SUBJECT: AMENDMENT NO.126 TO FACILITY OPERATING LICENSE NO. DPR-50

THREE MILE ISLAND NUCLEAR STATION, UNIT NO. 1

AMENDMENT TO FACILITY OPERATING LICENSE

Amendment No. 126
License No. DPR-50

CORE PROTECTION SAFETY BASES

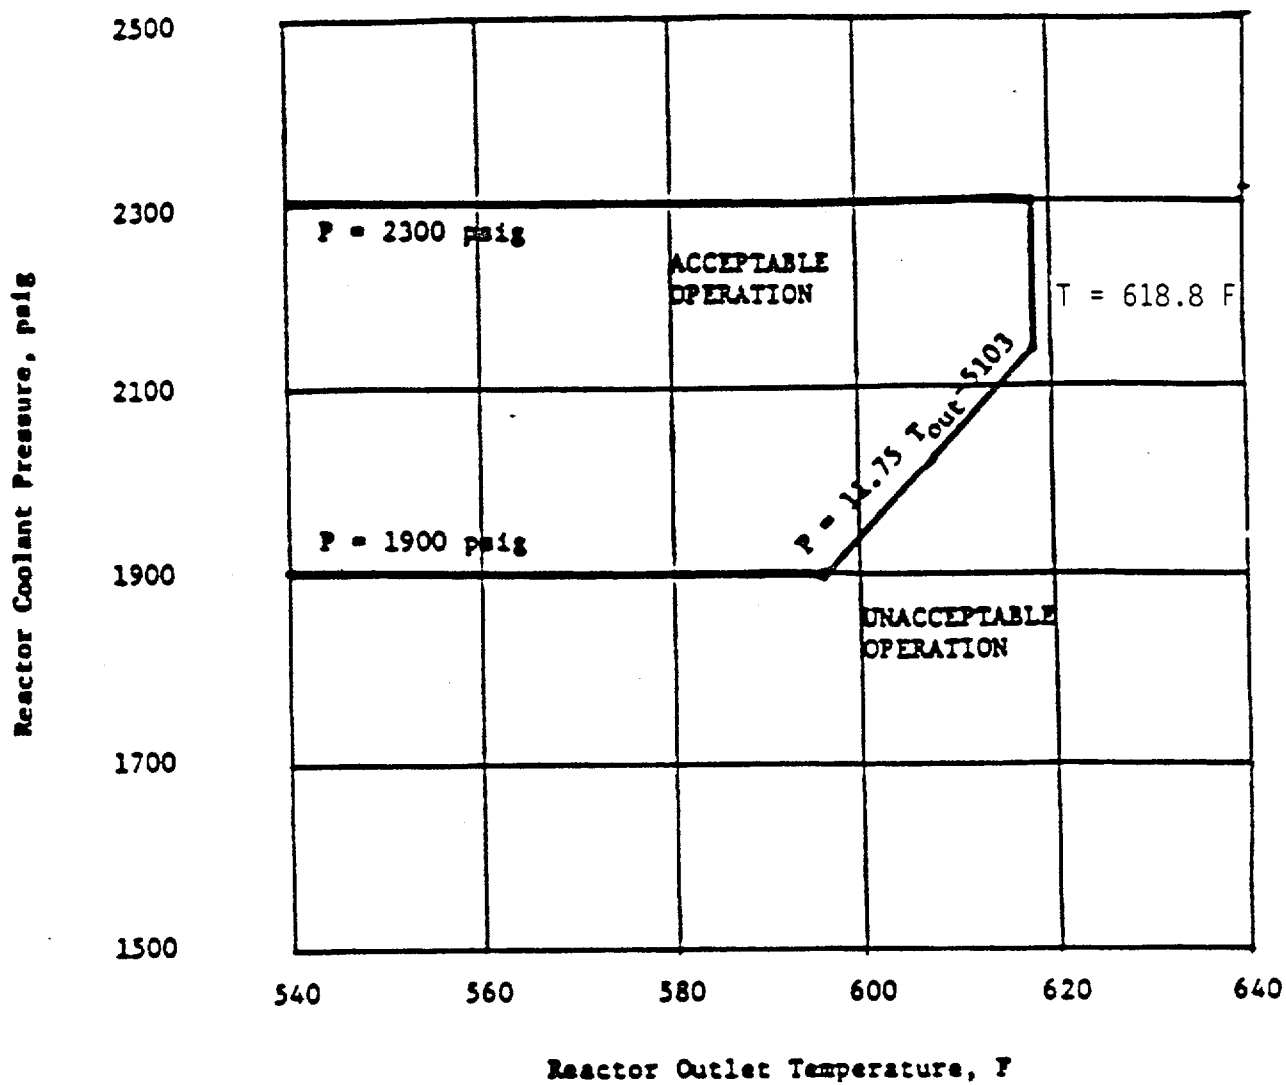
The description of the curves on Figure 2.1-3 is changed to indicate that the curves no longer represent minimum DNBR conditions. This change is acceptable since it more accurately describes the curves presented on the figure.

5. Figure 2.1-3, Core Protection Safety Bases

The curves on this figure have been revised to reflect small changes in the 2 and 3 pump allowable power levels. This change is acceptable since it reflects the revised Reactor Protection System instrument errors.

Figure 2.3-1

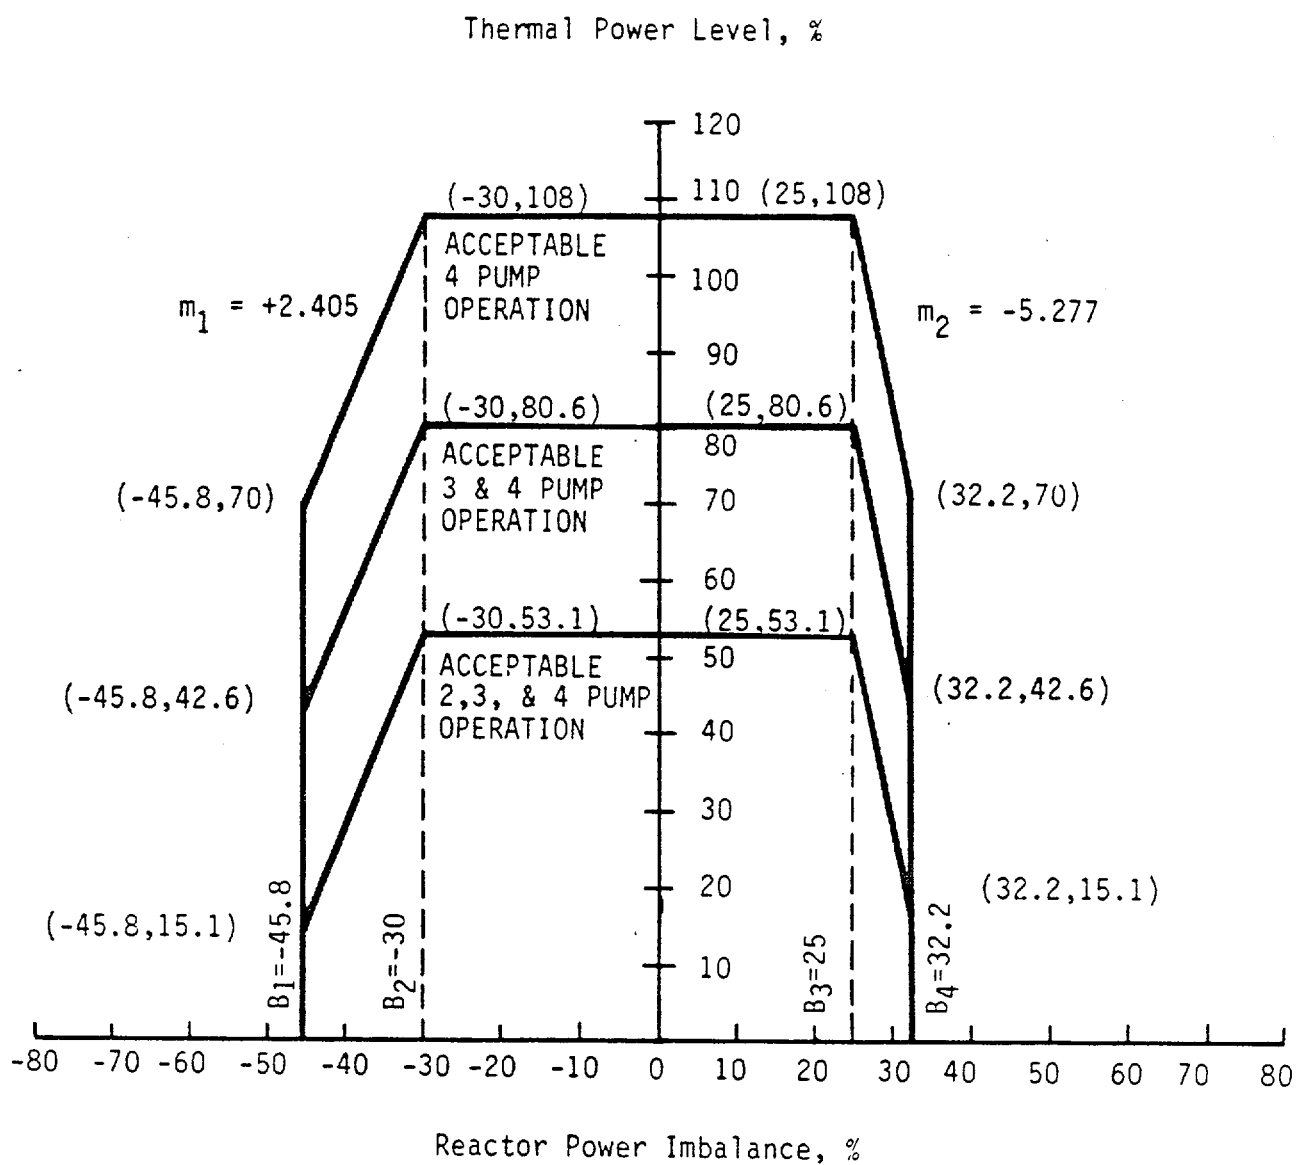
10. Figure 2.3-1, Reactor Protection System Maximum Allowable Setpoints

This figure has been revised to reflect the change in the high reactor coolant outlet temperature trip setting discussed in Item 8 above and is, therefore, acceptable.

Figure 2.3-2

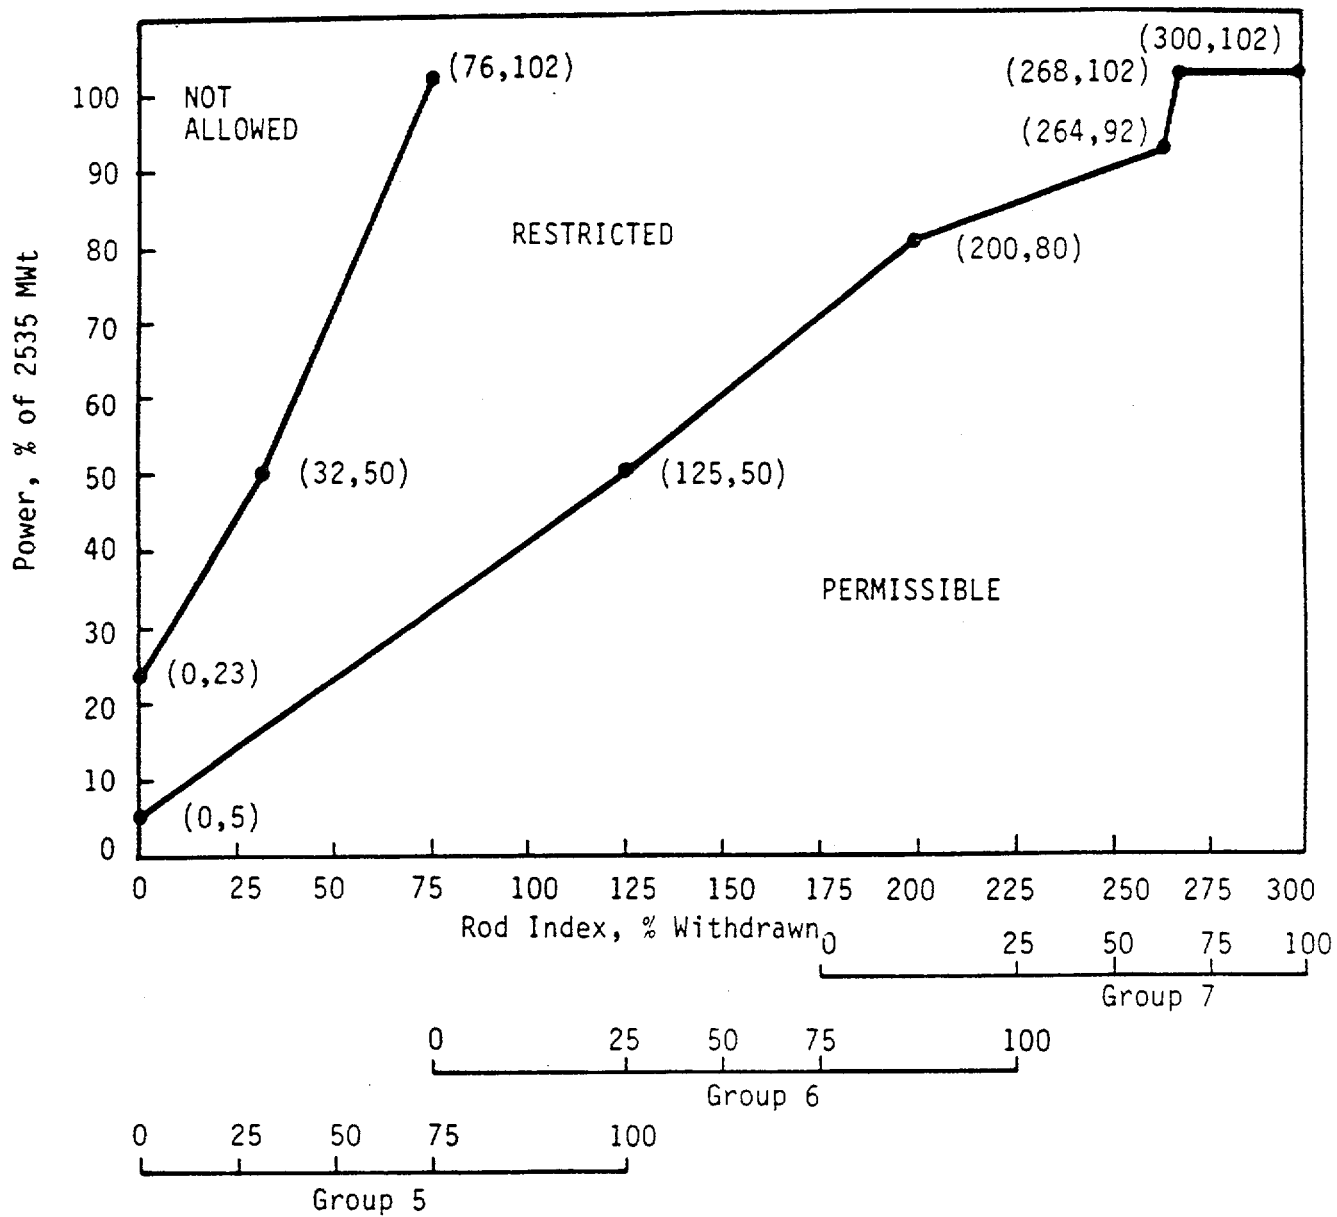
11. Figure 2.3-2, Reactor Protection System Maximum Allowable Setpoints for Power Imbalance

The figure is based on the Cycle 6 analyses discussed in previous sections of this Safety Evaluation. A flux/flow setpoint has been maintained to provide additional margin for the Cycle 6 pump coastdown analysis. Since the power/imbalance limits on the figure conservatively bound the thermal limits, they are acceptable.
